SERVICE BULLETIN

GOVERNOR ELECTRONIC CONTROL UNIT (ECU) REPLACEMENT

SB600N-050, Governor Electronic Control Unit (ECU) Replacement

ENGINE, FUEL AND CONTROL - INTRODUCTION OF REVERSIONARY GOVERNOR ELECTRONIC CONTROL UNIT (ECU)

Figure 1. ECU Harness Cover Modification

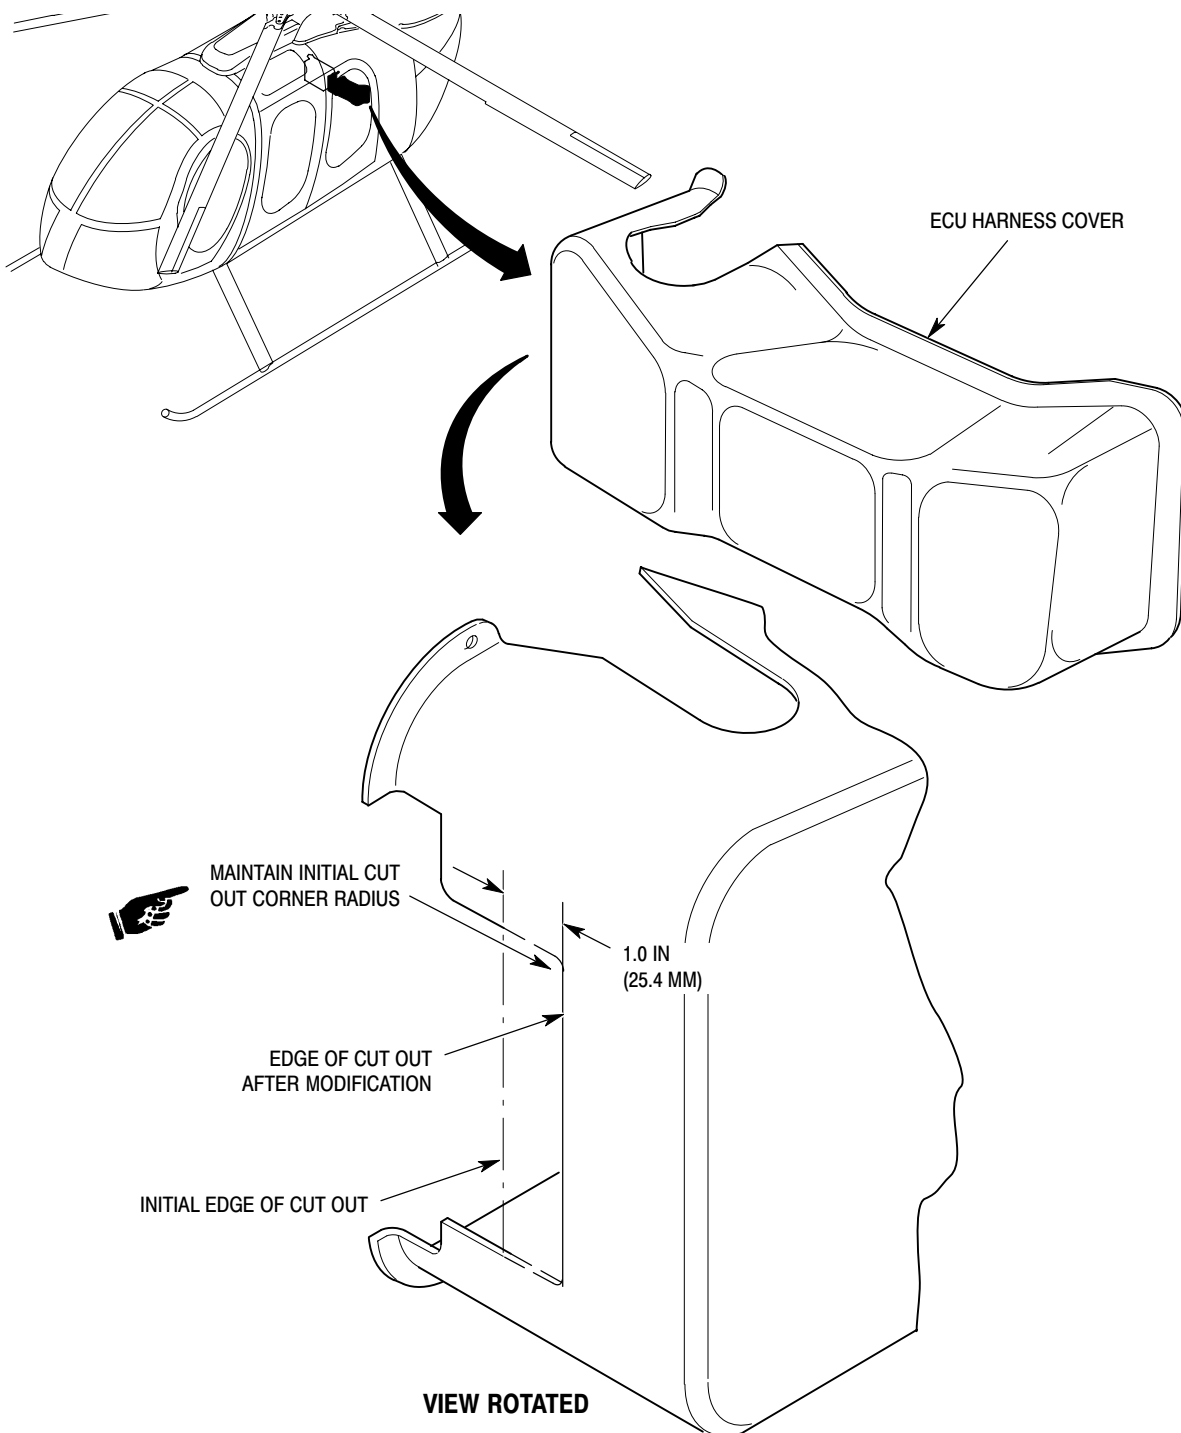
This bulletin also has instructions to modify the Custom Aircraft Interiors MD600-6200-138 ECU harness cover, if installed.
